**MONTGOMERY COUNTY
PLANNING COMMISSION**

June 27, 2025

SUBJECT: MCPC #18-0322-009
SOPI – 1 Belmont Avenue

Re: MCPC #18-0322-007
Plan Name: 1 Belmont Avenue
(17,700 sq. ft. commercial on approximately 6.76 acres)
Situate: City Avenue (N); Belmont Avenue (E)
Lower Merion Township

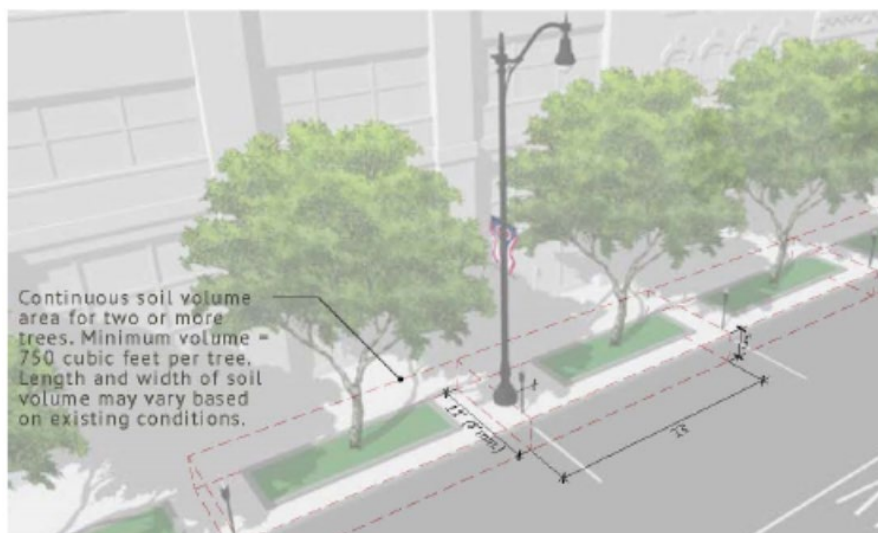
- A. Handicapped Parking and Access to Existing Office Building. Several handicapped parking spaces are shown on either side of a pedestrian walkway in the southern parking lot near the entrance to the existing office building. An ADA curb ramp is shown on either side of the pedestrian walkway connecting to a loading zone between ADA parking spaces on the civil plan set; however, no curb ramps in these locations are shown on the landscape plan.
